The courtyard as the family's haven · a study in phases · Phase 0: the facts · Taif / Palm House V10.0

The owner's brief (10 Nov 2026): breeze, water, tree, shade, winter sun, views, privacy, calm, beauty, easy upkeep, all working together; find every mistake. **Locked:** the site and the outline, the structure, the stair and the lift, the settled rooms, the malqaf L5. **Open:** the seating, the water and the tree, the outlet (A or B), the sink window, the courtyard's doors and windows, the arch infill, the lighting, the floor, the planting, the drainage. **Owner's preferences:** no TV; every seat with a back, 5–6 seats; open to the sky; level floor, movable furniture; render and paint, porcelain floors; simple switches; privacy only from the guest route and the majlis side. **Amber = an assumption.** Phase 0 cites the files; Phase 1 checks them.

Phase 1 · the 22 checks (and the owner's two notes) · pass / fail / unknown, with the numbers

Phase 2 · the mistakes, ranked · why each matters and how big it is · what the open items can fix

Phase 0 · the courtyard as designed: plan (clear faces) and the east–west section through the seating · the summary

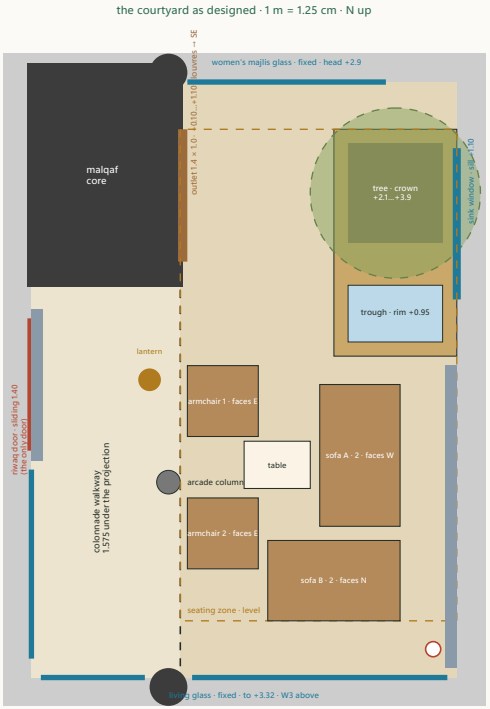
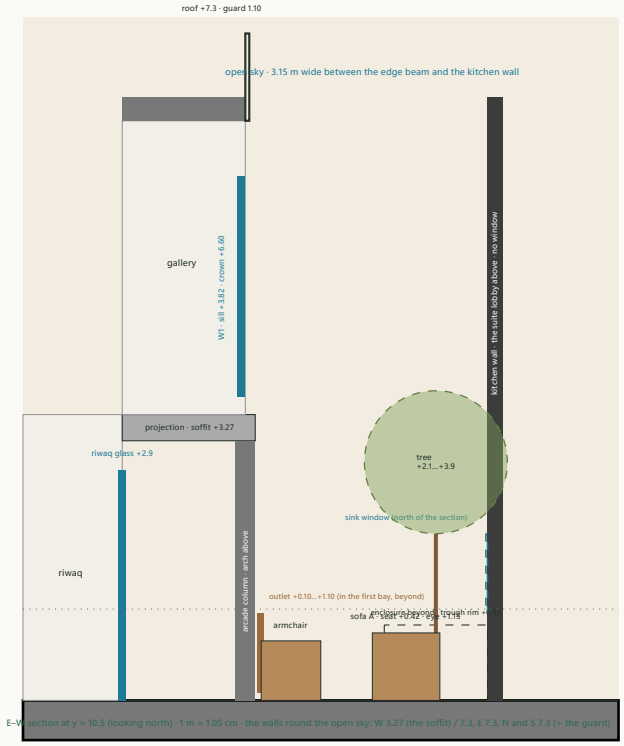
- **The courtyard:** an L of 27.19 m² on axes, ≈ 24.88 m² clear, 4.50 wide between the riwaq glass and the kitchen wall, 6.30 long; the open sky 3.15 × 6.5 m between the projection's edge beam and the kitchen wall, 7.3 m deep (the roof) on three sides and 3.27 m (the soffit) on the colonnade side. The floor level, the porcelain finish, falls of 1 % to the kitchen wall foot.

- **Who opens onto it:** the women's majlis (fixed glass, north), the living (fixed glass to +3.32, south, W3 above), the riwaq (the sliding door 1.40 and fixed glass, west), the kitchen's sink window (east, +1.10…+2.10, behind the enclosure), the gallery's W1-2 and W1-3 (west, above the colonnade), the family living's W2 × 2 (north, above the majlis glass); the suite lobby above the kitchen wall is blind. **One door only** (the riwaq); the malqaf door opens onto the covered strip, not the courtyard.

- **Air:** the malqaf core fills the arcade's first bay; the outlet A low on its east face, 1.4 × 1.0, louvres to the south-east, ≈ 1.79 m³/s at 2.1 m/s in the mean summer-evening wind (W / NW); B would raise and turn it toward the trough. D1 / D2 spring-return on one switch.

- **Water and tree:** one box on the kitchen wall in front of the sink window; the tree north (planter 1.0 × 1.05 × 0.7, rim +0.45), the raised trough south (1.0 × 0.6 × 0.35, rim +0.95, water +0.85, a laminar lip +1.05), a pump in the divider, both basins to the rain system. The species **not decided** (laurel or clipped ficus), the canopy drawn Ø1.8 at +2.1…+3.9.

- **Seating:** six seats with backs (two 2-seat sofas, two armchairs, a table) in the level zone 2.925 × 5.2 (12.09 m² free), facing the outlet arch and the enclosure; no TV.

Phase 1 · the sun: where the floor and the seats are lit (the sky opening's shadow) · the N–S section at winter noon · the summary

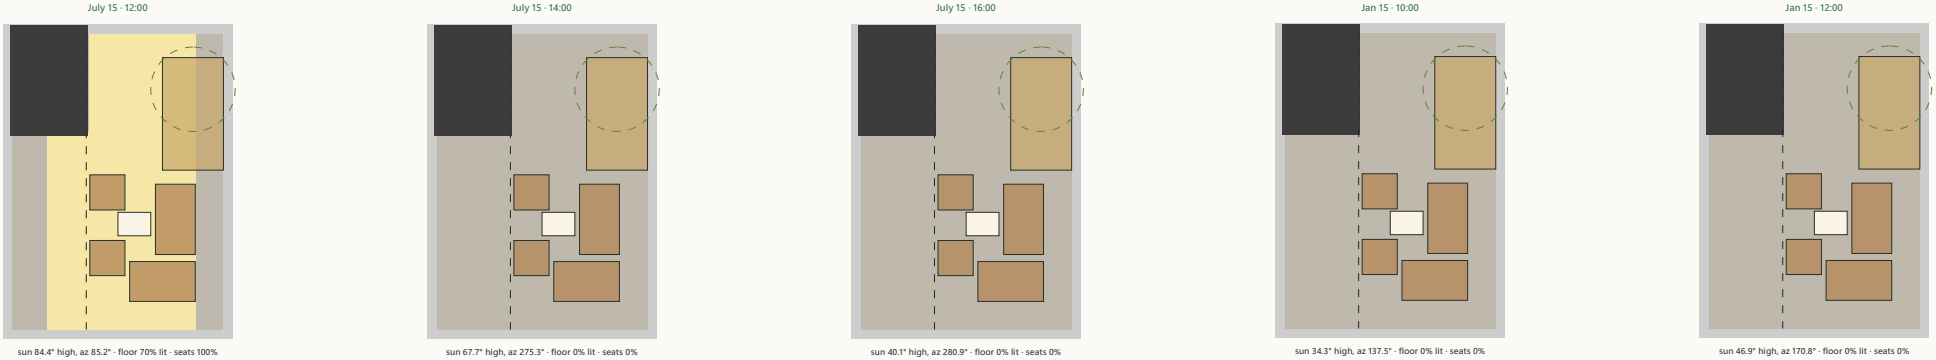
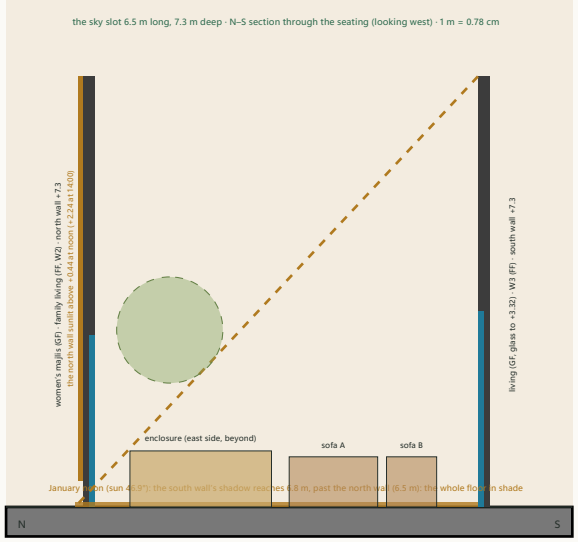
- **The biggest finding is the well.** The sky slot is 3.15 m wide between 7.3 m walls (1 : 2.3; the sky view from a seat ≈ 7 %): **no direct sun reaches the floor or any seat from October to February**; in summer the floor is shaded from about 13:30 (good). The walls are rooms, so the well stays; what the open items can do is live with it: the north wall's face is in the winter noon sun above +0.5, so a seat with its back to the women's majlis glass gets the sun on the body for ≈ 2 h; the light render, the lanterns, a taller tree in the slot, the living's door.

- **The air works but hits the faces (A):** the low outlet aimed at the seats puts the jet's top at +1.44 on sofa A's sitters (eye +1.15) and misses the water and the tree. The raised, turned outlet (B) fixes both: the air over the trough and under the crown, the seats in the spill.

- **The water and the tree are in the wrong relation:** the crown hangs 0.08 m from the trough (leaves in the water), the laminar lip is inaudible, the planter (0.7 m^3) is too small for a ficus (roots, the drains) and small for a laurel; no skimmer, no root barrier.

- **Use:** the conversation square and the clearances are right (11, 12); two of the four seats look at a wall (10); the women's majlis's fixed glass gives no privacy from women guests (13); **the living has no door** onto its own courtyard (23): 9.5 m round by the riwaq against 4.9 m through the glass; a sliding door at x 6.05–7.45 is the clearest single gain; no door from the majlis.

- **Not designed yet:** the lighting and the power (17, 21); the acoustics are hard (18); the planting is one tree (19).
- **Phase 2** ranks these; **Phase 3** draws 2–3 layouts within the open items (the outlet B, the seating turned to the water and the north wall, the enclosure re-made with the tree away from the water, a skimmer, the living's door, the lighting, the floor pattern, the planting) and lists the bolder ideas (the well) for the owner.
